Technical Service Bulletin

43 Replaced adaptive damping suspension control module cannot be coded

43 13 19 2034162/1 June 17, 2013.

Figure 1. Parts Bulletin in ETKA.

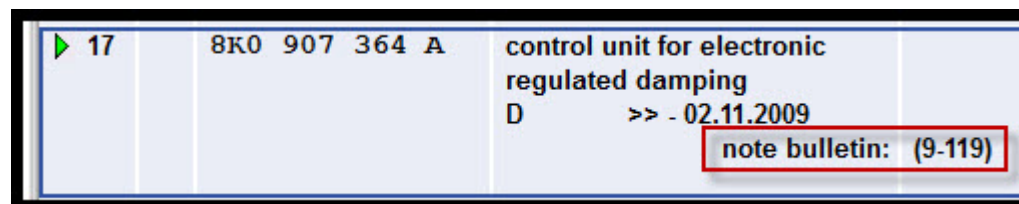
A new generation of the adaptive damping suspension control module, J250, was placed into production. The new generation control module must be coded and parameterized using an SVM code, which is listed in the attached ETKA Parts Bulletin, 9-119. This parts bulletin can be found in the ETKA Remarks for the part number (Figure 1).

When replacing the adaptive damping suspension control module, J250, perform an SVM coding and parameterization using the provided SVM code.
